**ADDENDUM No. 4**  
**REQUEST FOR TENDER ARIBA Doc4913427082**  
**CLOSING DATE: 12:00 NOON (LOCAL TIME), January 24, 2025**  
**For: The Union Station Third Floor Security Offices Renovations, Located at 65 Front Street West, Toronto**

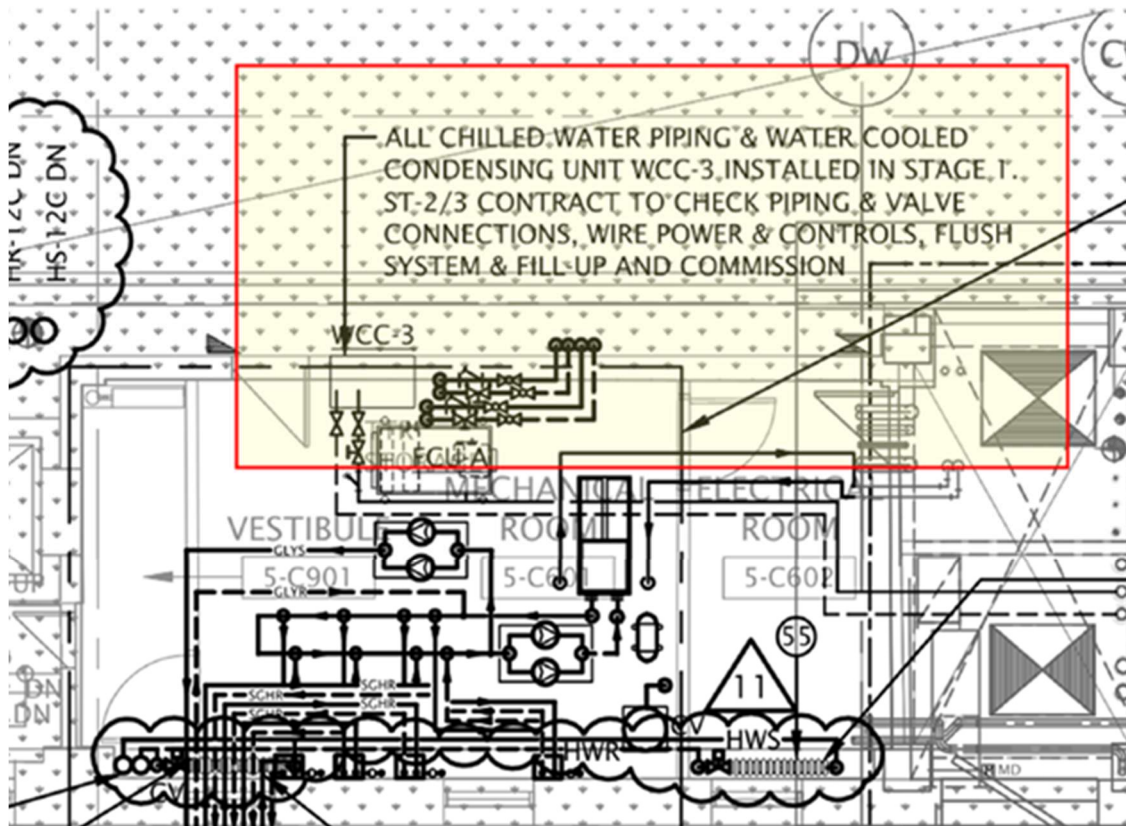
**Q20** – Can you please provide refrigerant pipe sizes for each run to water cooled condensers shown on M21-03-06 Dwg?

**A20** – Refrigerant piping sizes will be based on manufacturers requirements. Please contact the Liebert company for the requested information.

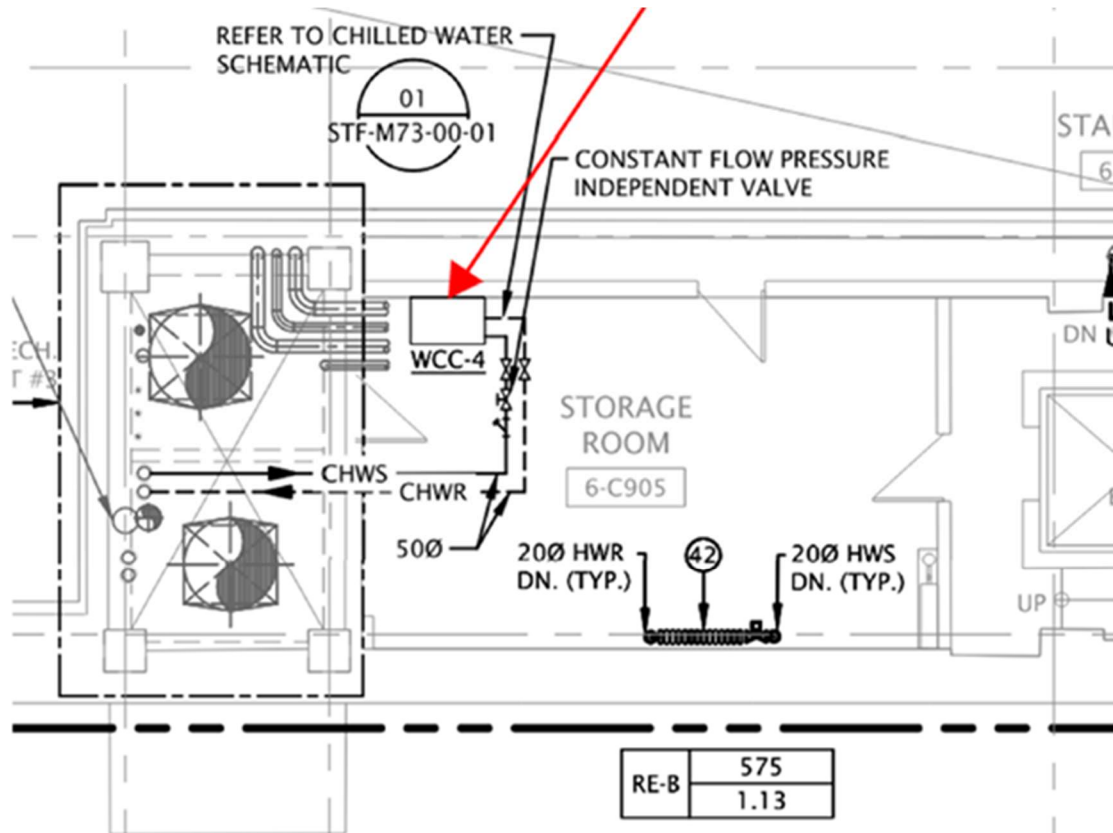
**Q22** – Can you please advise whether the WCC-3, and WCC-4 are existing and installed in location?

**A22** – WCC-3 and WCC-4 are existing units that have been already installed. WCC-3 is installed on the 5th Floor Mechanical Room 5-C601. Piping from WCC-3 routes into mechanical Shaft #5.

WCC-4 is located on the 6th Floor Storage Room 6-C905. Piping from WCC-3 routes into mechanical Shaft #53

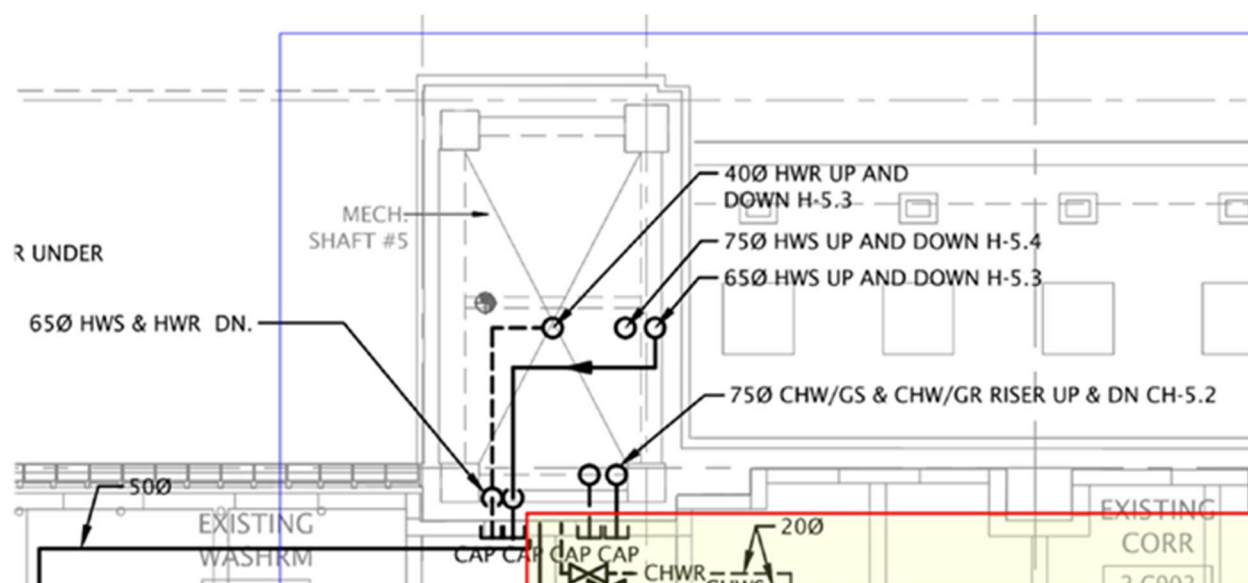
**Q26** – Can you please provide routing of new domestic cold water piping for water cooled PAC-12, and PAC-13 and tie-in location?

**A26** – DCW piping is not required. PAC-12 and PAC-13 are to be connected to the condenser from the 2nd floor ceiling chilled water supply and return.
